**Re: EnCana Oil And Gas Partnership (EnCana) Application No. 1394112**  
**Canadian Natural Resources Limited (CNRL) Application No. 1409180**  
**Husky Oil Operations Limited (Husky) Application No. 1481725**  
**Cold Lake Oil Sands Area – Clearwater Deposit**

**Response of EnCana Oil and Gas Partnership (EnCana) to  
Board Staff (Board) Questions on EnCana Input/Output Files  
Dated April 13, 2007**

Figure 1: Oil Recovery Factor of EnCana's runs of Husky's Jan 30, 2007 2D HWCSS Model (April 5, 2007 submission) and EnCana's Rerun Husky's No depletion Model with Gas Well Shut in  
(Husky's 2D HWCSS Models: d08gc-2d-NoDep\_tight)

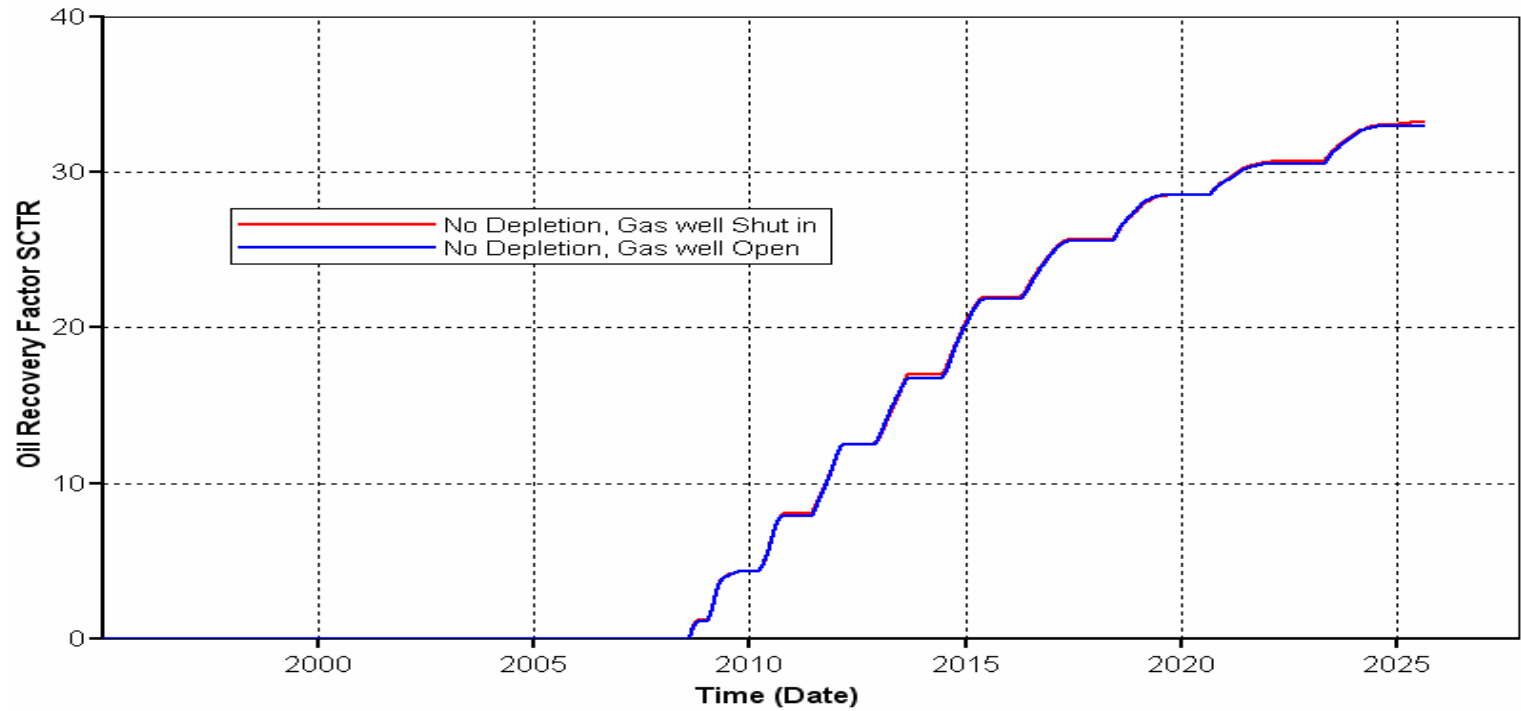
1. With respect to EnCana's re-run of Husky's January 30, 2007 model runs, it appears that in the non-depleted HWCSS case the gas well was produced, but in the non-depleted HSAGD case the gas well was not produced. Discuss the effect not producing the gas well in the non-depleted HWCSS case would have on the predicted results.

EnCana's models and Husky's model, when run with acceptable material balance errors, have consistently shown that there is no impact of gas cap production on HWCSS and HSAGD oil recovery factors. Therefore, we do not expect any significant changes to the results of the non-depleted HWCSS case if the gas well was shut in.

EnCana has rerun Husky's non-depleted HWCSS case (January 30, 2007) with gas well shut in. As expected, there is no significant difference in results from those submitted for this case in our April 5, 2007 submission. For the non-depleted HWCSS case, an oil recovery of 33.3% OBIP was obtained for the gas well shut in compared to 33.0 %OBIP for the case in which the gas well was produced. The cumulative SOR was 6.2 m<sup>3</sup>/m<sup>3</sup> for both cases. The summary results for these two cases are presented in Table 1 and Figure 1 and 2. Table 1 and Figures 1 and 2 also compare the results of these two cases to the results of the depletion case already provided in EnCana's April 5, 2007 submission.

**Figure 3: Summary of Oil Recovery Factor - EnCana's Rerun of CNRL GOR Models with Gas Cap and High Pressure HWCSS and EnCana's Rerun GOR 1 Model with Gas Cap Pressure at 200 kPaa**

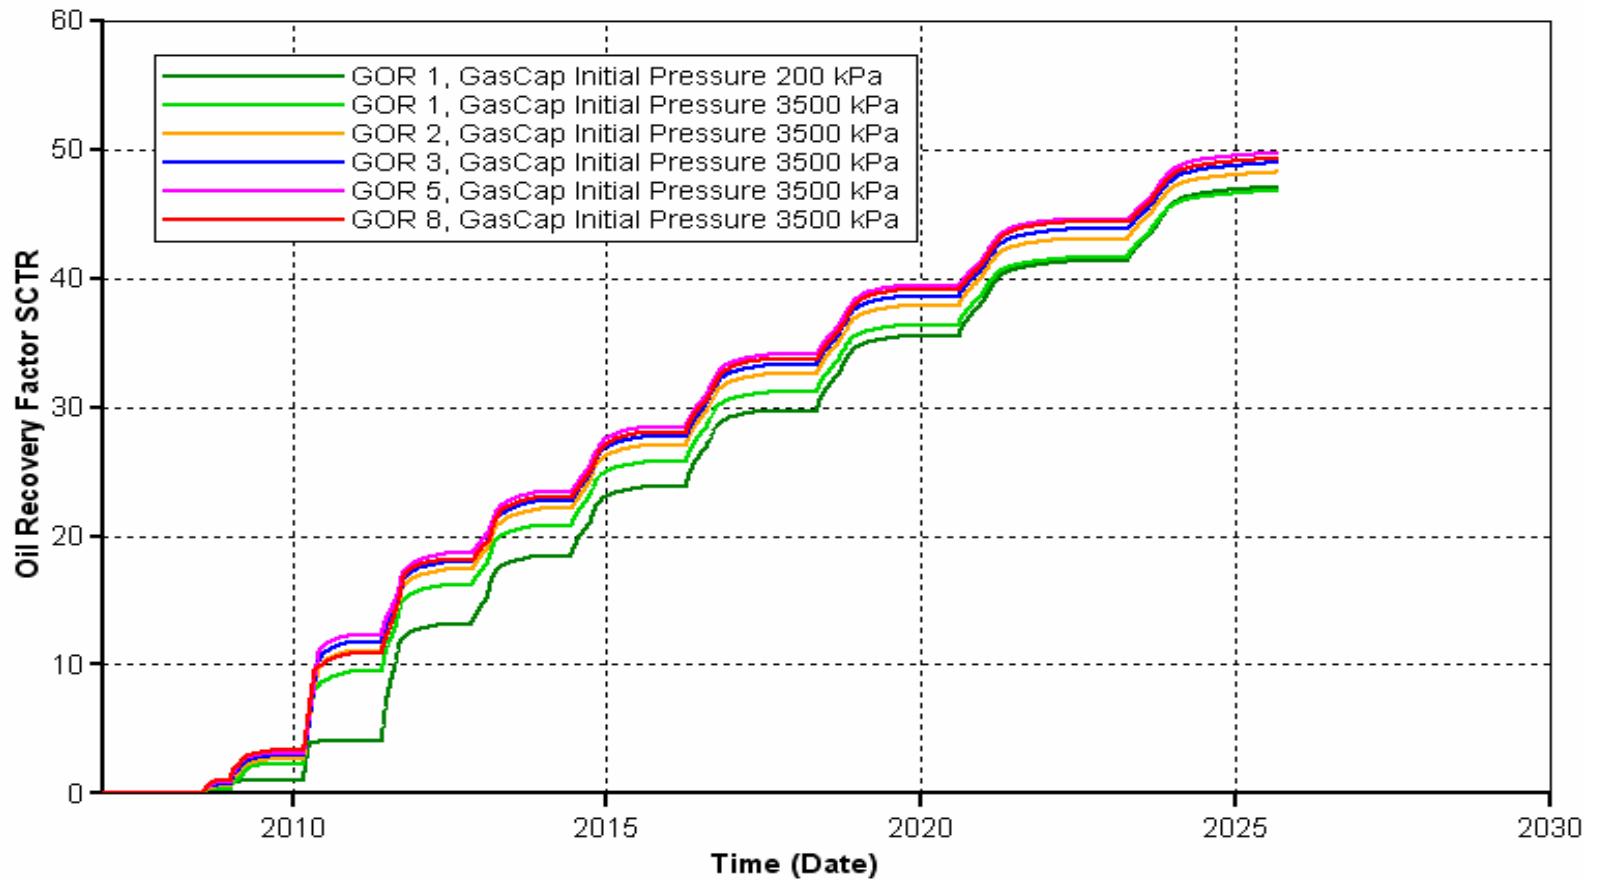
3. With respect to EnCana's re-run of CNRL's model with high pressure instead of low pressure CSS, it appears that for the GOR = 1 case, the gas cap added to the model by EnCana was kept at the initial pressure of 3500 kPa. Shouldn't the gas cap have been depleted to a low pressure (such as 200 kPa) for the GOR = 1 case? Discuss the effect this would have on the predicted results.

Correct observation was made by Board Staff. We initialized the model, GOR=1 at a reservoir pressure of 3500 kPa to make it consistent with CNRL's model with GOR =1 (CNRL's January 30, 2007 submission) which was initialized at a pressure of 3500 kPa. We do not expect any significant changes to the results of the GOR=1 case if the gas cap was depleted to a low pressure such as 200 kPa.

EnCana has rerun GOR=1 model with an initial gas cap pressure of 200 kPa. As we expected, there is no significant difference in results from those submitted for this case in our April 5, 2007 submission. The GOR=1 case with a low gas cap pressure of 200 kPa achieved 47.1% OBIP oil recovery. This oil recovery factor is in good agreement with a recovery factor of 46.8% OBIP achieved for the GOR=1 case with the gas cap initialized at a pressure of 3500 kPa. The cumulative SOR is 6.5 and 6.7 m<sup>3</sup>/m<sup>3</sup> for gas cap pressure of 200 kPa and 3500 kPa respectively. The summary results for these two cases are presented in Table 2 and Figure 3 and 4. Table 2 and Figures 3 and 4 also compare the results of these two cases to the results of the GOR= 2, 3, 5 and 8 cases already provided in EnCana's April 5, 2007 submission (input and output files).

Results of the rerun of the CNRL's model with high pressure injection (Table 2) show that the bitumen recovery factor is similar for GOR = 3, GOR =5 and GOR =8 at approximately 49% OBIP. The maximum difference in bitumen recovery factor between GOR=1 (gas cap at 200 kPa) and GOR=8 is only 2.2% OBIP. However, it should be recognized in the field it is unrealistic to expect a GOR =1, over a reasonable gas production time, since the bitumen zone is very large in comparison to the size of the gas cap.
